FALCON SERVICE BULLETIN

FALCON 2000

No 407-R1

**REMOVAL OF THE TIE-DOWN SYSTEM INSTALLED FOR
CARGO TRANSPORTATION**

Figure 1: TIE-DOWN SYSTEM INSTALLATION-CONFIGURATION 1

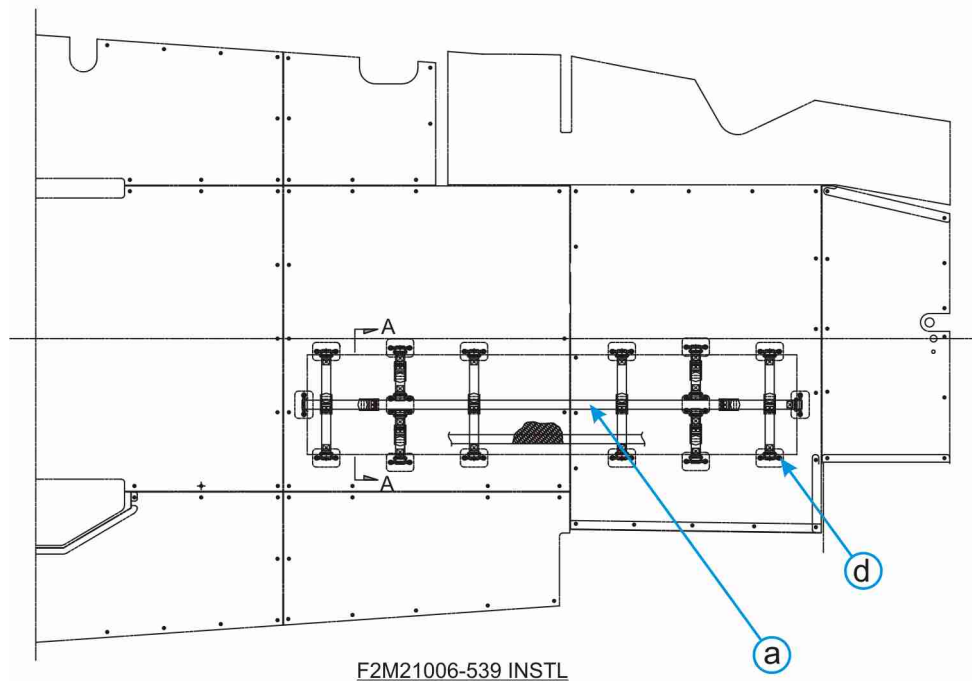
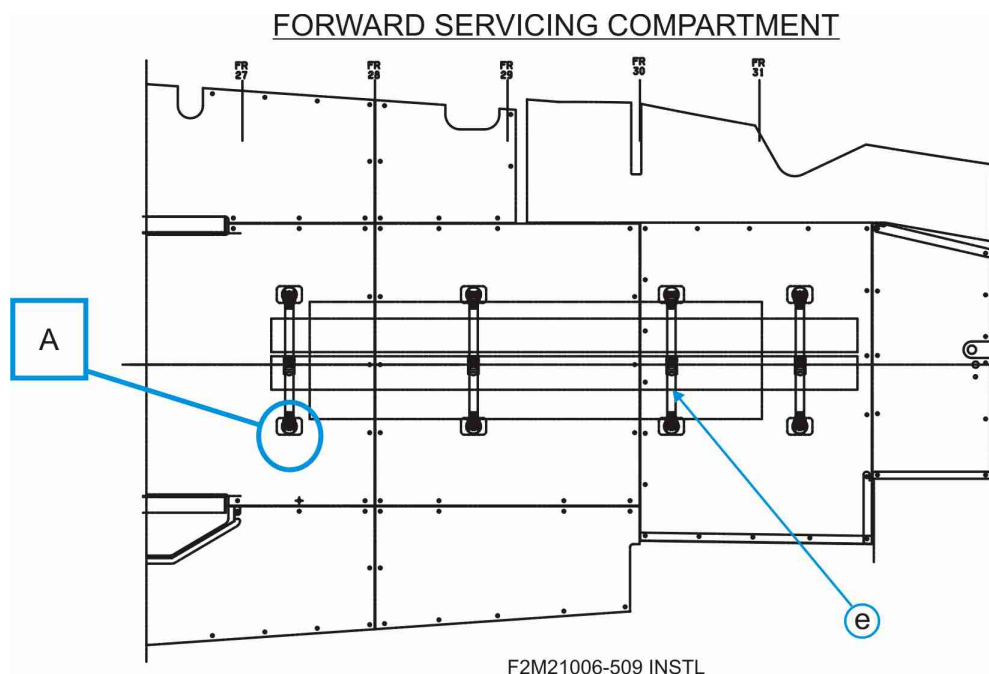
- (a) Configuration 1 (**fig. 1**)

- 1 Release the webbing (a-fig. 1).
- 2 Remove the buckles (b-fig. 1) from the footman loops (c-fig. 1).
- 3 Remove the webbing (a-fig. 1).
- 4 Remove the screws (d-fig. 1) from the footman loops (c-fig. 1).
- 5 Remove the footman loops (c-fig. 1).
- 6 Install the new screws (P/N: NAS603-14P) and the washers (P/N: NAS1149F0332P) (d-fig. 2) in place of the old screws.
- 7 Tighten the screws.

Figure 2: TIE-DOWN SYSTEM INSTALLATION-CONFIGURATION 2

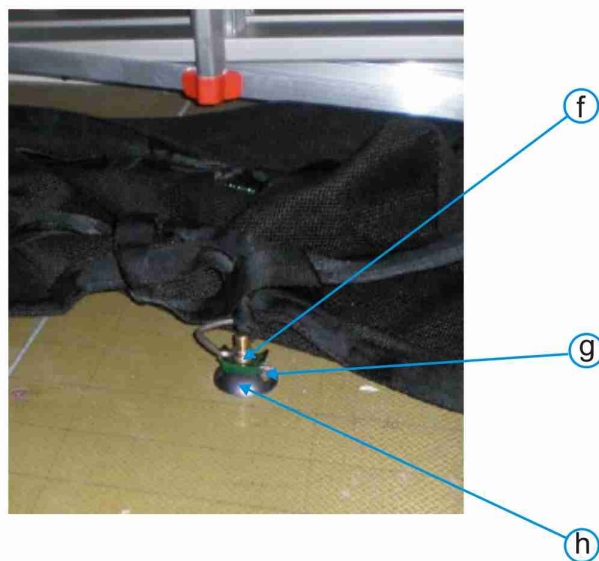
- (b) Configuration 2 (**fig. 2**)

- 1 Release the webbing (e-fig. 2).
- 2 Remove the tie-down straps (f-fig. 2) from the tie-down fittings (h-fig. 2).
- 3 Remove the webbing (e-fig. 2).
- 4 Remove the screws (g-fig. 2) from the tie-down fittings (h-fig. 2).
- 5 Remove the tie-down fittings (h-fig. 2).
- 6 Install the new screws (P/N: NAS603-14P) and the washers (P/N: NAS1149F0332P) in place of the old screws (g-fig. 2).
- 7 Tighten the screws.

Figure 3: TIE-DOWN SYSTEM INSTALLATION-CONFIGURATION 3

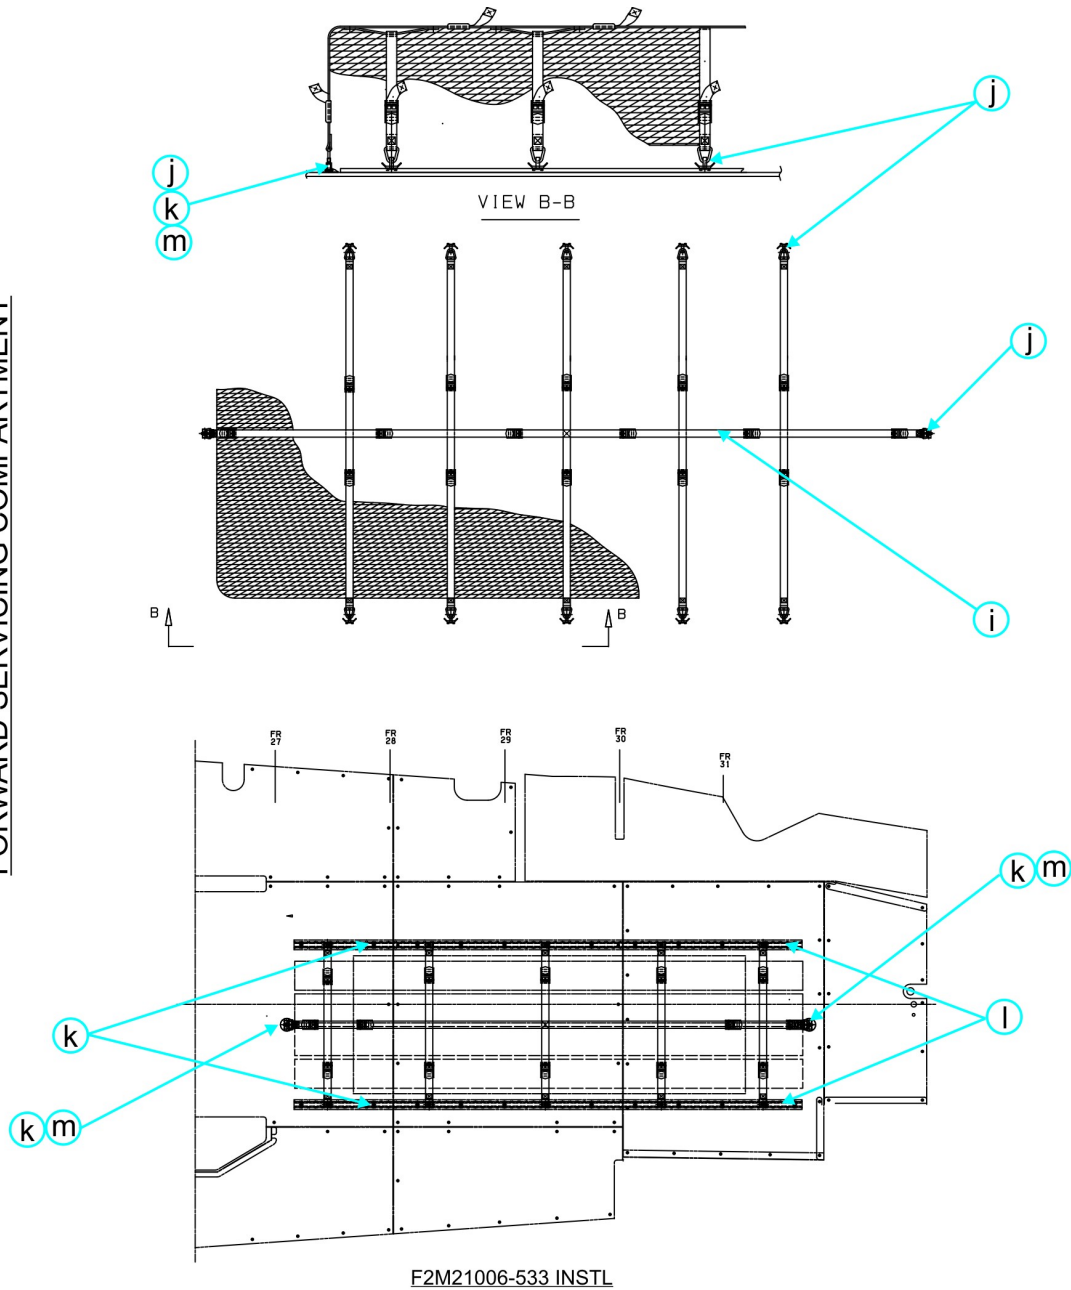
- (c) Configuration 3 (**fig. 3**)

- 1 Release the webbing (i-fig. 3).
- 2 Remove the tie-down straps (j-fig. 3) from the tracks (l-fig. 3).
- 3 Remove the tie-down straps (j-fig. 3) from the tie-down fittings (m-fig. 3).
- 4 Remove the webbing (i-fig. 3).

- 5 Remove the screws (k-fig. 3) from the tie-down fittings (m-fig. 3).
- 6 Remove the tie-down fittings (m-fig. 3).
- 7 Remove the screws (k-fig. 3) from the tracks (l-fig. 3).
- 8 Remove the tracks (l-fig. 3).
- 9 Install the new screws (P/N: NAS603-14P) and the washers (P/N: NAS1149F0332P) to replace the fasteners of the tie-down fittings (m-fig. 3) (plate equipped with anchor nut under the floor panel).
- 10 Tighten the screws.
